Independent Review of Tank 241-AY-101 Fitness for Service

C.W. Stewart (Editor)

February 2003

Figure 2.3. Minimum and Measured Wall Thickness in AY-101

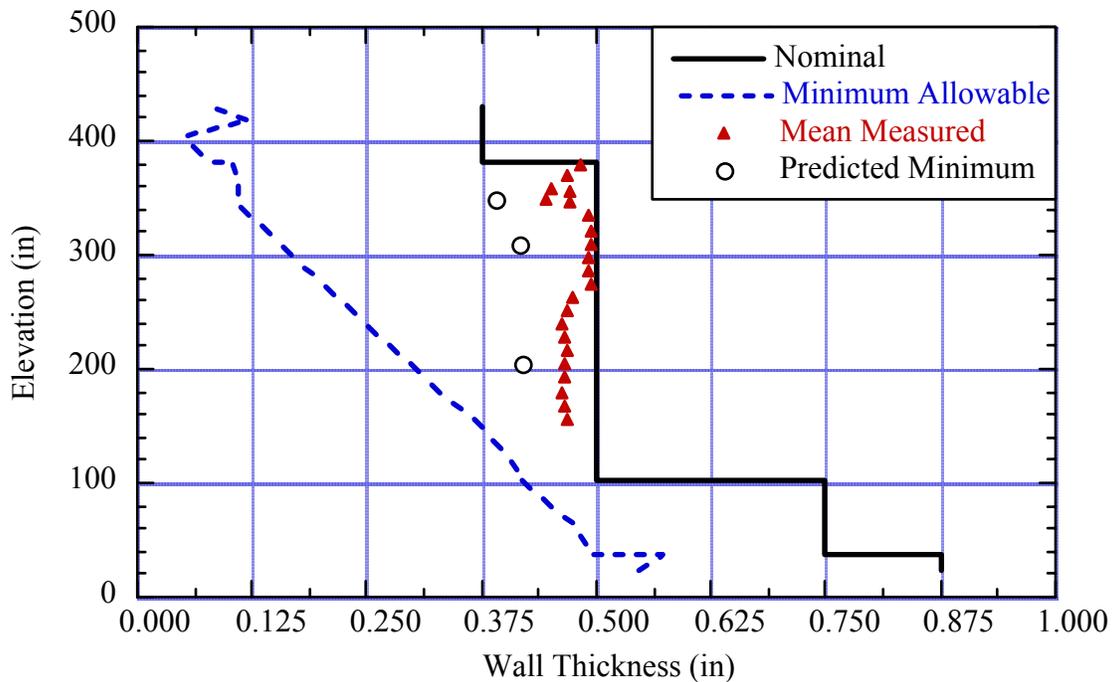
The measured wall thickness and the minimum required thickness are plotted versus elevation in Figure 2.3. The minimum wall thickness generally decreases with elevation and is shown by the dashed line. The nominal design wall thickness is shown as the solid line. Note that the minimum wall thickness margin occurs at the 100-inch elevation, where the plate thickness decreases from 3/4 to 1/2 inch. The mean wall thickness measured by UT and the minimum thickness predicted by the extreme-value statistical analysis are shown as triangles and circles, respectively. It is clear that even the minimum predictions provide a very comfortable margin above the allowable thickness (note that the abrupt decrease in measured wall thickness below 262 inches probably represents installation of a thinner-than-nominal plate).

CH2M HILL response: The last item in Section 3.8 of RPP-13361 refers the reader to Appendix F, where the minimum wall thicknesses taken from Table B-8 of WHC-SD-WM-ER-556 are given along with a description of the structural analysis that produced them. A plot similar to Figure 2.3 of this report is included to compare measured wall thickness to the minimum as a function of elevation.
